OAKLAND HARBOR

DEEP-DRAFT NAVIGATION IMPROVEMENTS
DESIGN MEMORANDUM NUMBER 1, GENERAL DESIGN

FINAL SUPPLEMENT I TO THE
ENVIRONMENTAL IMPACT STATEMENT
ALAMEDA COUNTY
CALIFORNIA

ADDENDUM TO THE FINAL SUPPLEMENT 1 TO THE ENVIRONMENTAL IMPACT STATEMENTS

FIGURE 2.1

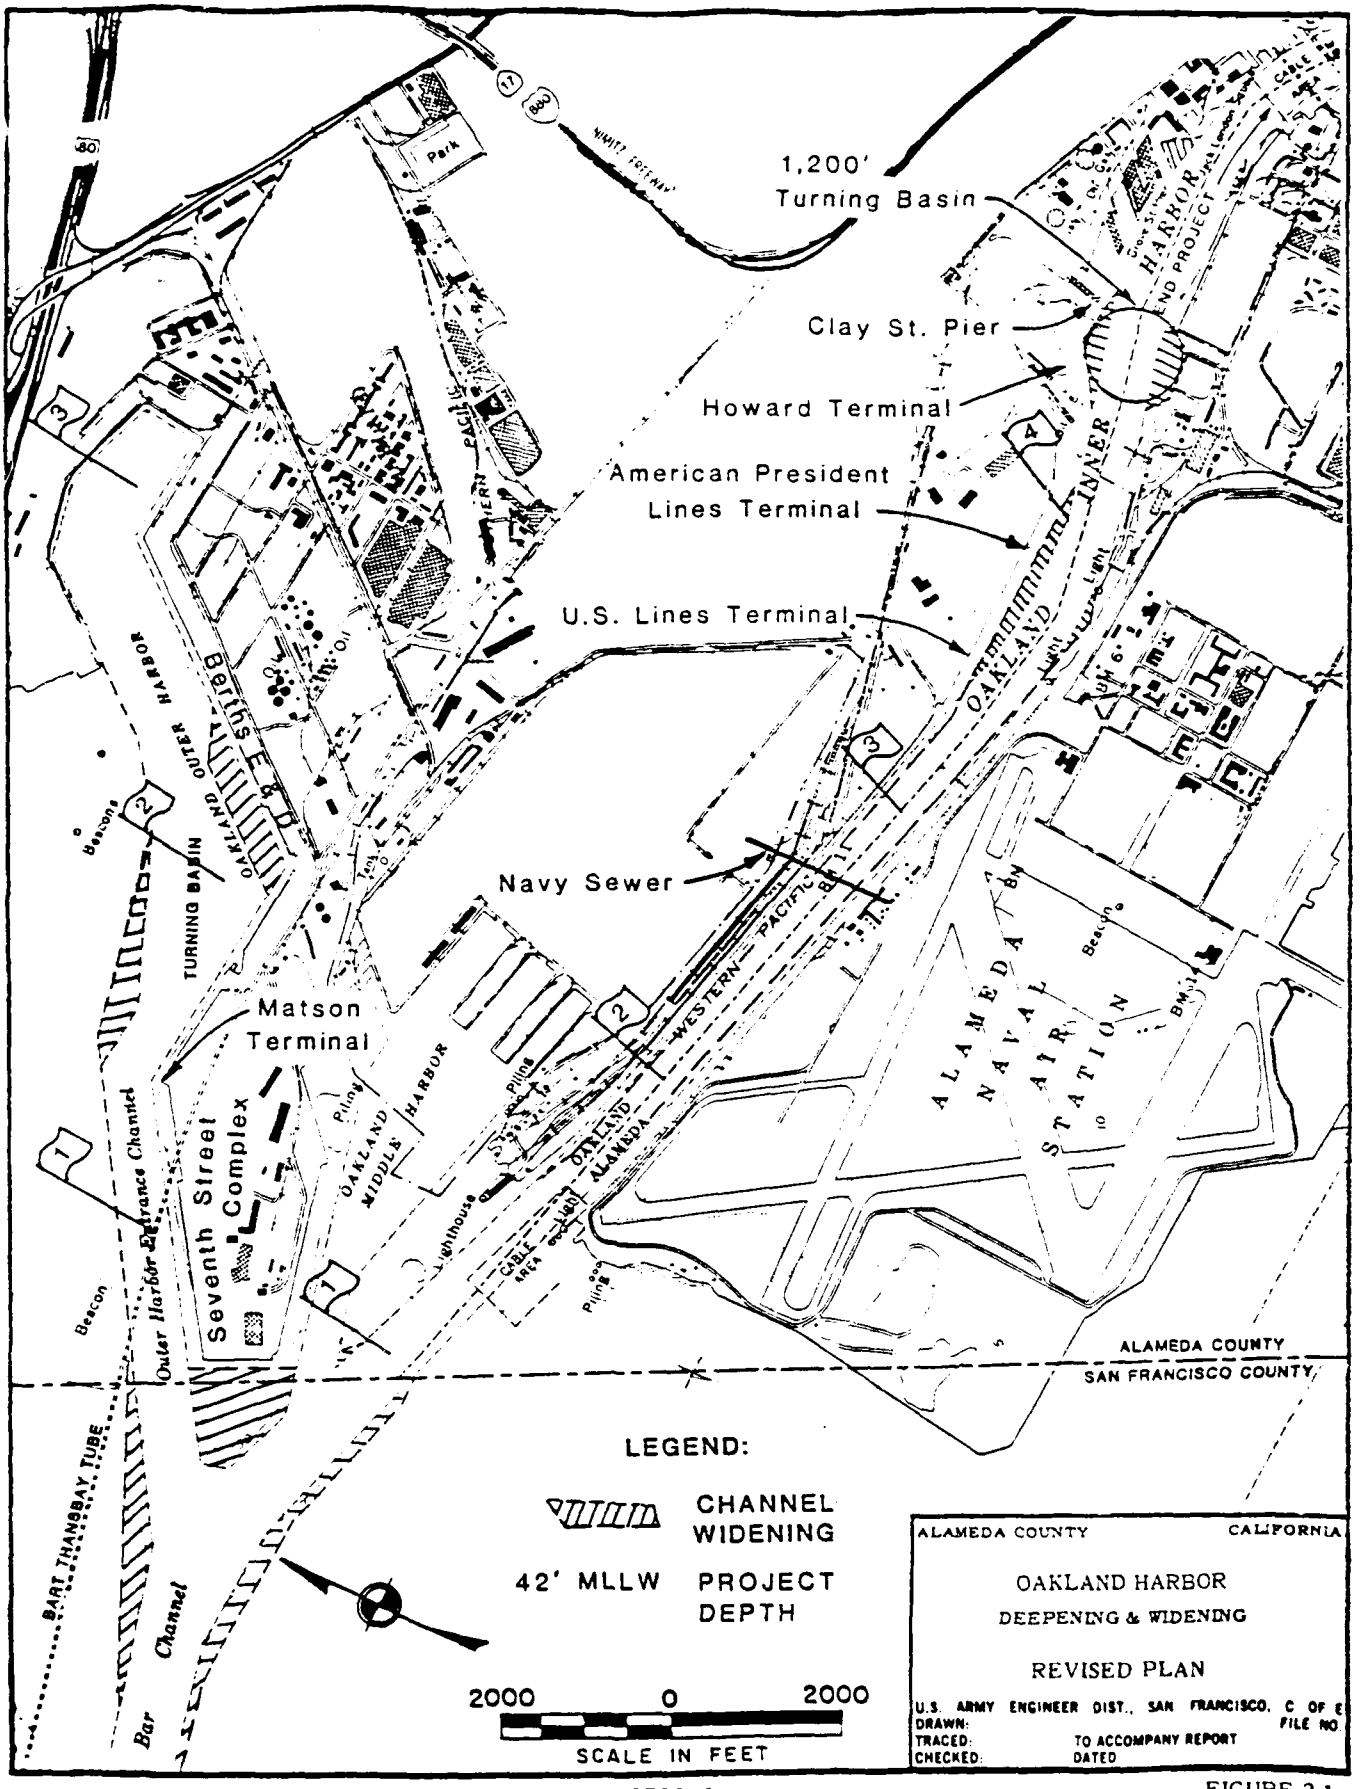
- o The SEIS and GDM should provide a map that highlights those locations to be dredged, not just a bathymetric chart. F-38
- o Maps of the offshore and in-Bay areas should include the location of the BART site (p. 23) and areas of the study area that may have oil and gas potential. F-39
- o Please send us Appendix C, Characterization of the Merritt/Posey Aquifer. F-40
- o The relevance of the South Tower Reference Site should be explained (Fig. 3.4). F-41
- o The List of Preparers should include the labs that performed the chemical and biological analyses, and the contractors used in document preparation. F-42

F-38 A map showing the locations to be dredged has been included in the SEIS, Figure 2.1.
